Model: B-C4	Date: 04-Feb-09	No.: RD059002h
-------------	-----------------	----------------

Subject: Firmware Release Note: Printer		Prepared by: J.Ohno	
From: 1st PP Tech Service Sect., PP Tech Service Dept.			
Classification:	<input type="checkbox"/> Troubleshooting <input type="checkbox"/> Mechanical <input type="checkbox"/> Paper path <input type="checkbox"/> Product Safety	<input type="checkbox"/> Part information <input type="checkbox"/> Electrical <input type="checkbox"/> Transmit/receive <input checked="" type="checkbox"/> Other (     )	<input type="checkbox"/> Action required <input type="checkbox"/> Service manual revision <input type="checkbox"/> Retrofit information <input type="checkbox"/> Tier 2

This RTB has been issued to announce the firmware release information for the **Printer**.

## Incorrect

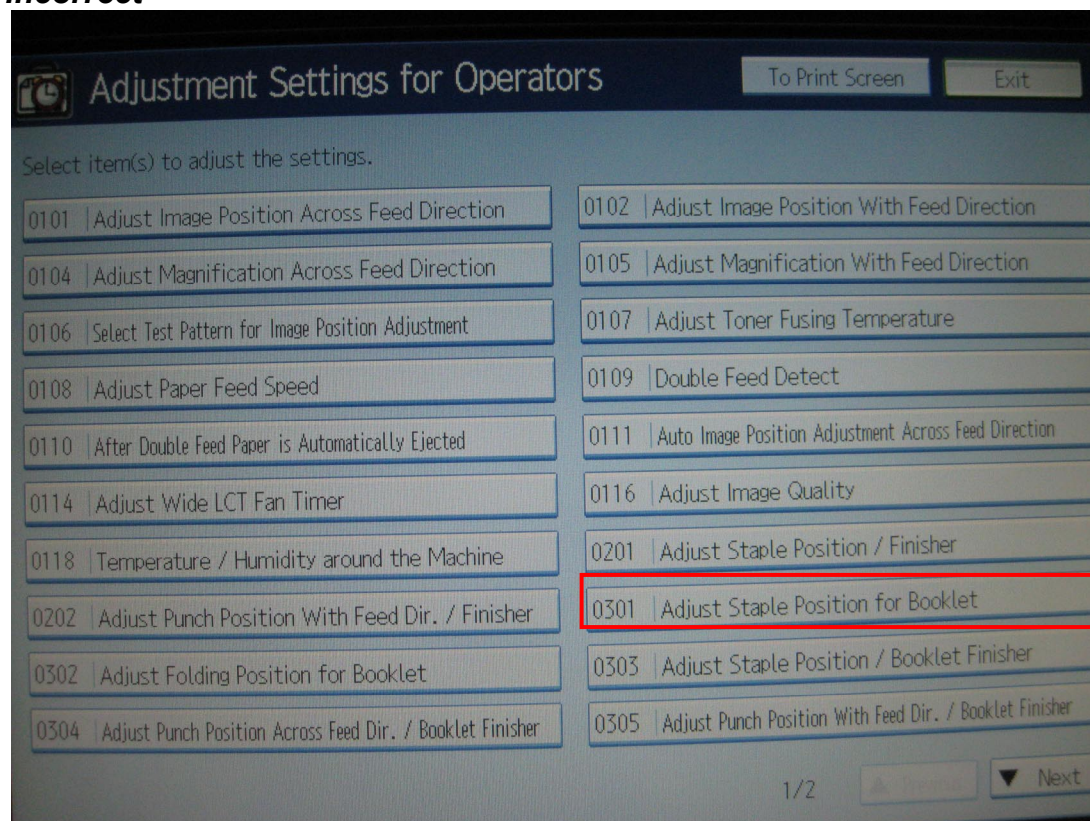
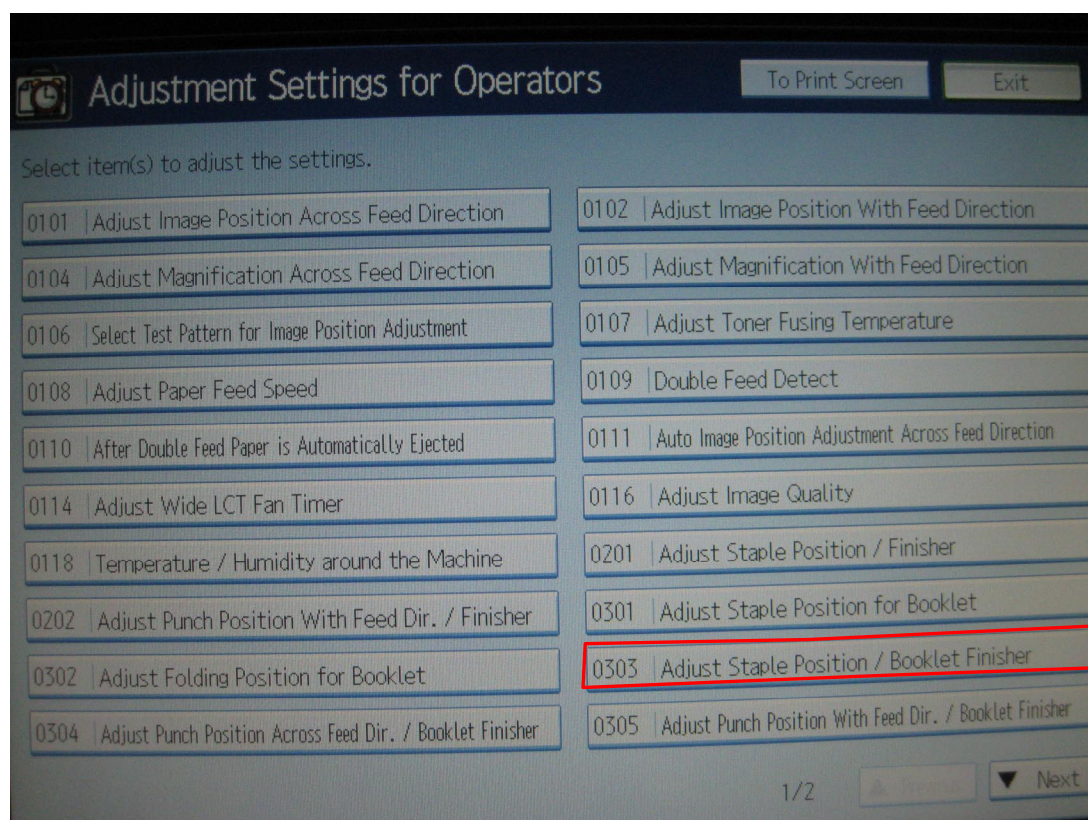
If this problem is reported from the field, please follow the instructions of SP 6208 or Adjustment Settings for Operators.

## Correct

**Correct diagram**

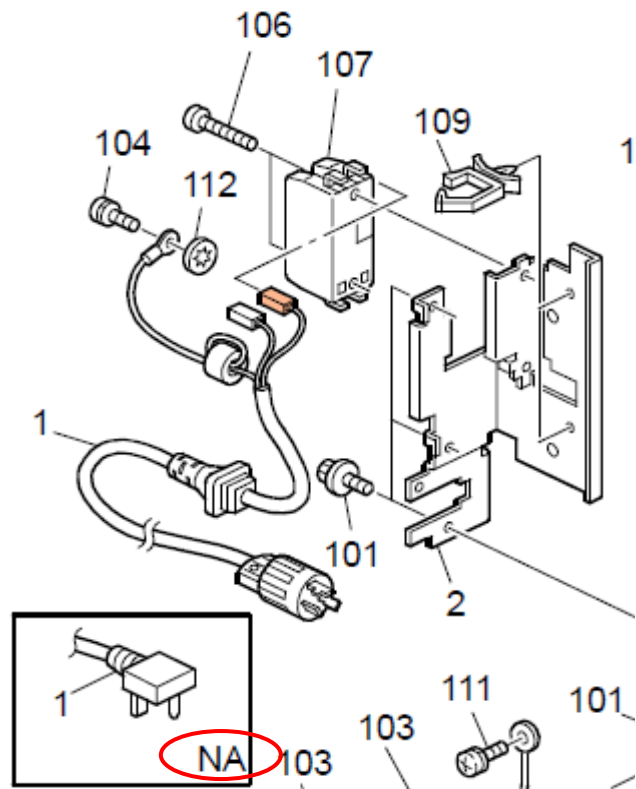
Model: Katana-C2(Bellini-C4)		Date: 20-Nov-09	No.: RD059048
Subject: Parts Catalog Correction		Prepared by: T.Mimura	
From: PPMC Service Planning Department 1G			
Classification:	<input type="checkbox"/> Troubleshooting <input type="checkbox"/> Mechanical <input type="checkbox"/> Paper path <input type="checkbox"/> Product Safety	<input checked="" type="checkbox"/> Part information <input type="checkbox"/> Electrical <input type="checkbox"/> Transmit/receive <input type="checkbox"/> Other (    )	<input type="checkbox"/> Action required <input type="checkbox"/> Service manual revision <input type="checkbox"/> Retrofit information <input type="checkbox"/> Tier2

**Change:** Shape of the tandem tray inner cover

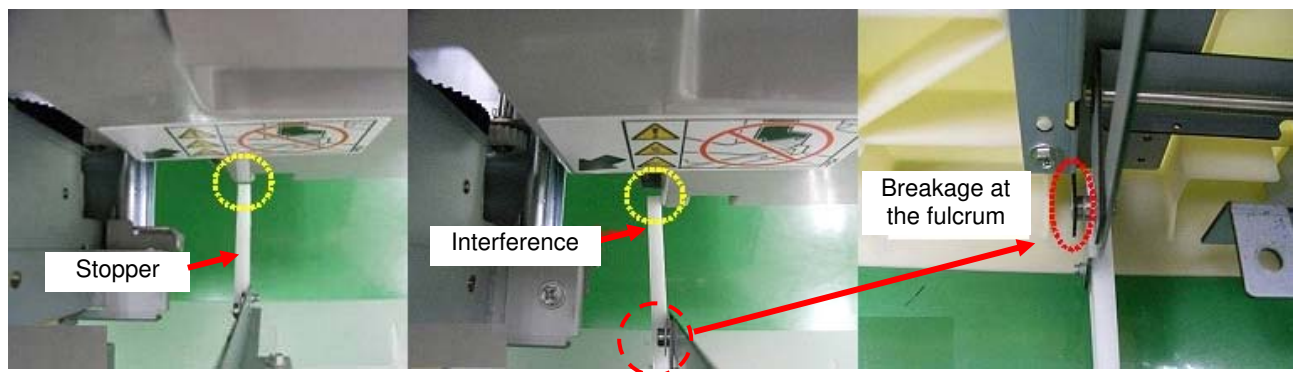
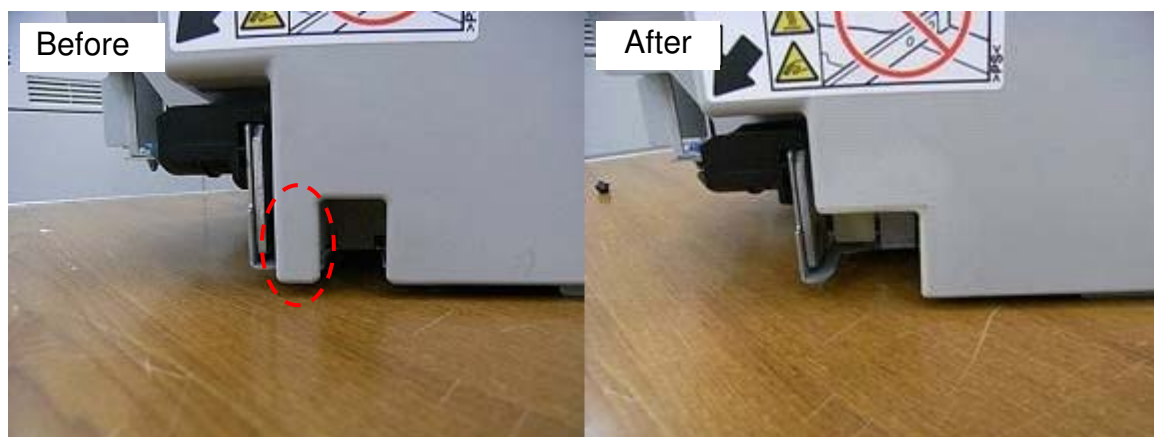
**Reason:** When closing the tray, the tip of the white plastic stopper (p/n: D0596702) could interfere with the tandem ray inner cover and damage the fulcrum of the stopper, disabling proper setting of the tray.

The bottom corner of the INNER COVER: TANDEM LCT (indicated with a red circle in the photo below) was cut out to prevent the stopper from interfering.

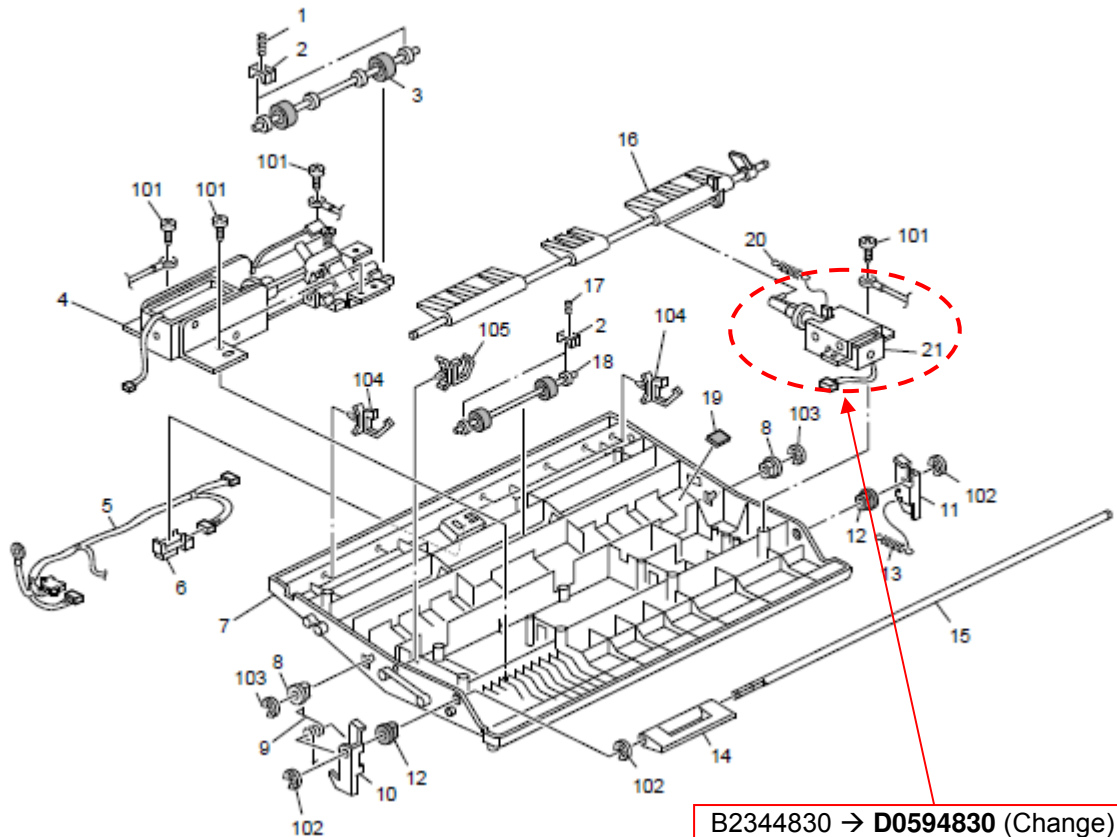
Old Part Number	New Part Number	Description	Q'ty	Int	Page	Index	Note
B2344830	D0594830	DC SOLENOID: GATE PAWL: SWITCHBACK: ASS'Y	1	X/O	137	21	Change
